This study observed erosion processes and some soil-hydrological properties at the headcut areas of two permanent gullies in Northeast China's Mollisols region during rainy and snow-melting seasons. Key parameters like soil moisture, temperature, and precipitation were investigated to understand water storage capacity, leakage processes, and suction stress levels. Although only two headcuts were monitored, I think the results could be of interest for the scientific community, but I would only recommend the publication of the work if a series of changes and improvements are carried out. In my opinion, the authors wrongly include methodological content and interpretations in the results section. These contents should be rightly placed in the corresponding section. Additionally, I miss some methodological details that I consider relevant (UAV data, processing, etc. see my comments below). Finally, figures must be notably improved, particularly the font size, please see my comments below. I detail these suggestions in the following lines:

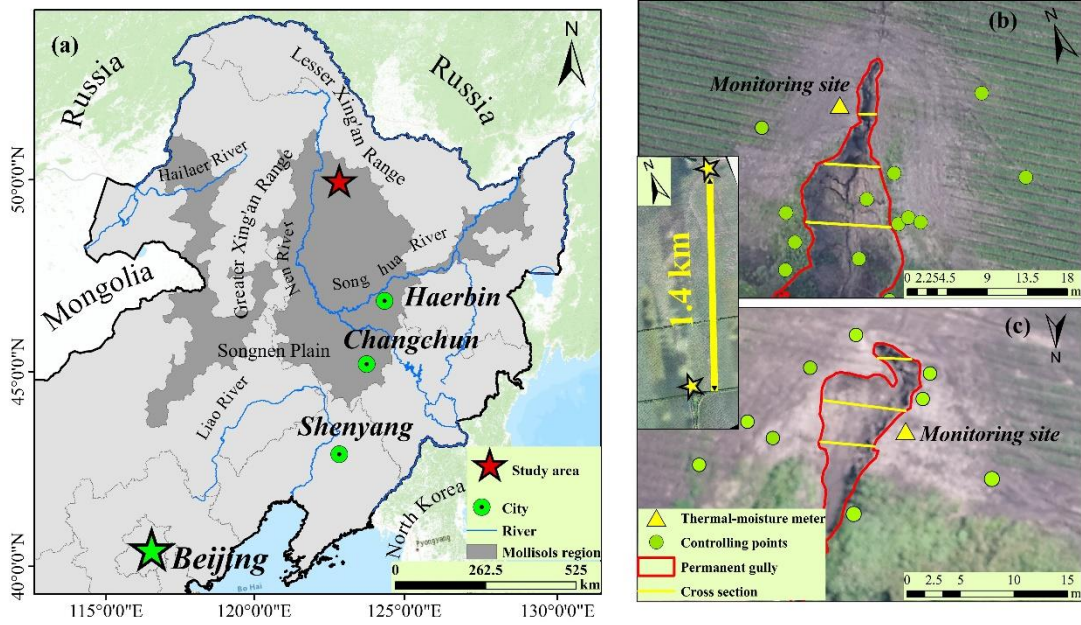
Figure 1. Should be improved, China is floating in the white. In general, some items in the figures are difficult to read, for example legend items in Figure 1c, the location map bewteen 1b and 1c is impossible to see.

Done. We revised the figure 1. The new figure is shown as follows:

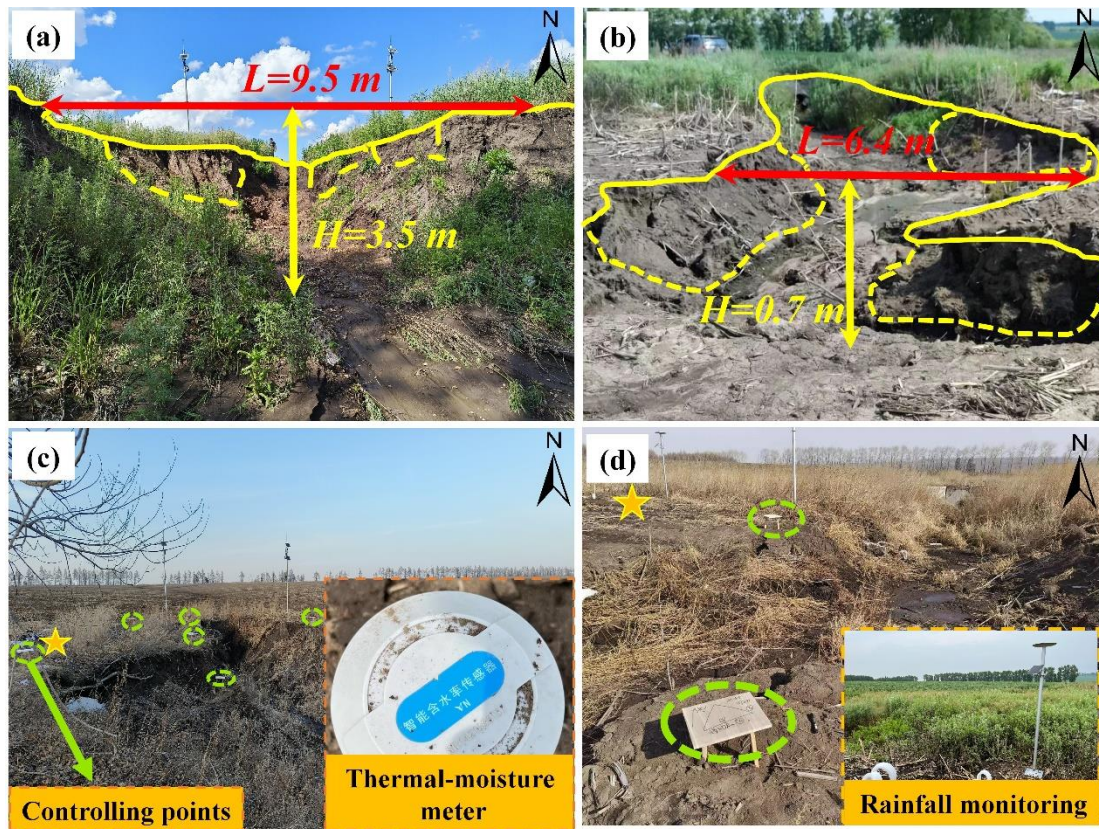
Fig. 2 Again some labels are very difficult to read, for example H in b.

Some labels in figure 2 are difficult to see. We improved the quality of the figure 2. The revised figure 2 is shown as follows:

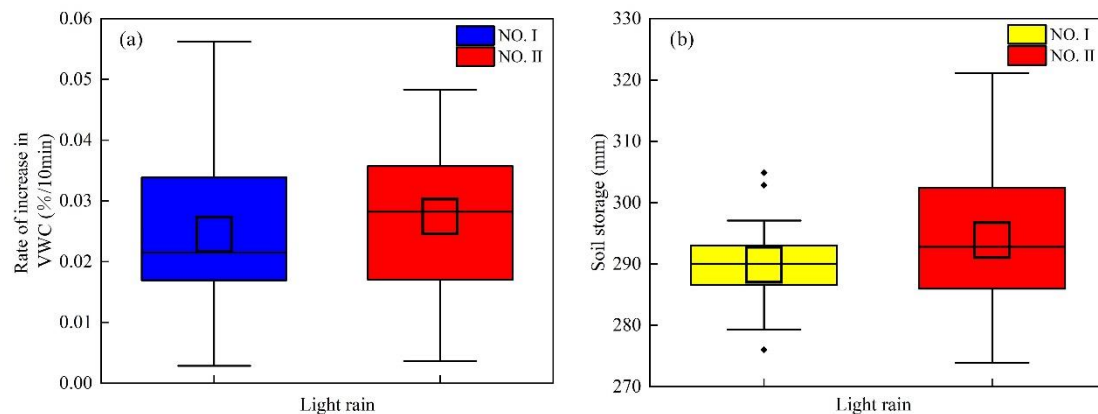
Fig. 8- I cannot see some details in (a), also happens in Fig. 9 (b)

We added a new figure to give a clear presentation of the figs. 8a and 9b.

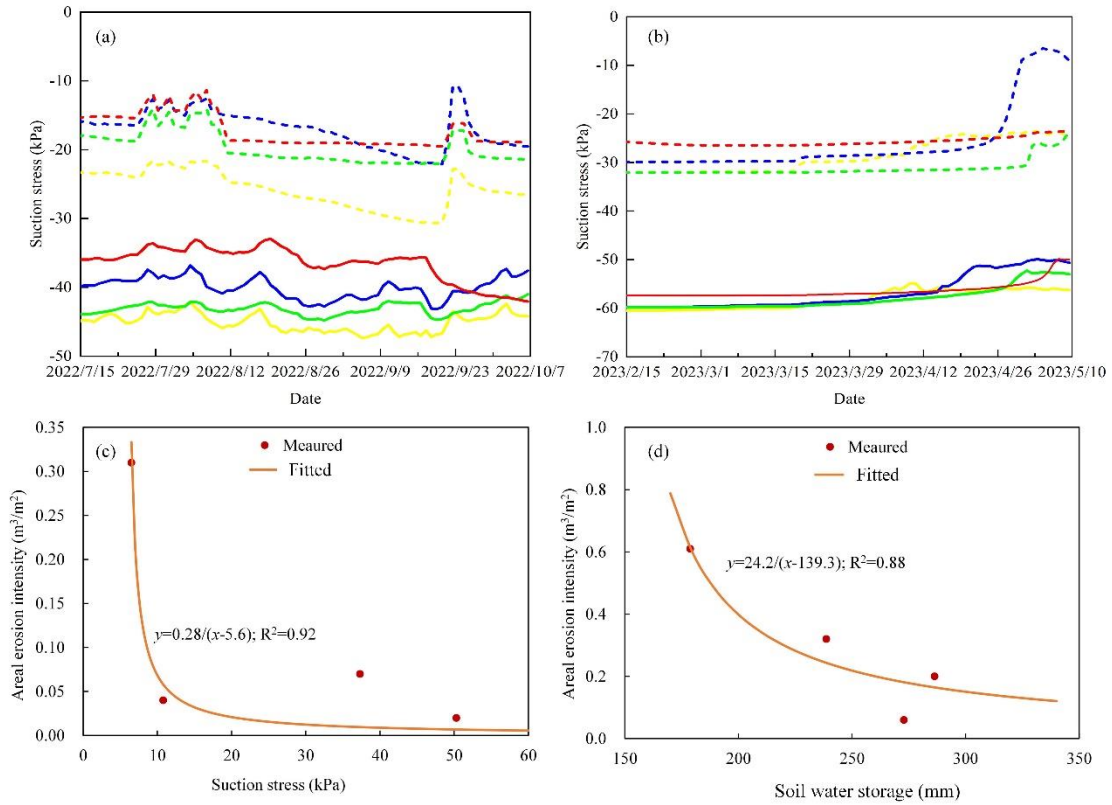
Fig. 10- the title of X-axis is not visible

I'm worry here to miss the title of X-axis in figure 10.

We already revised it.
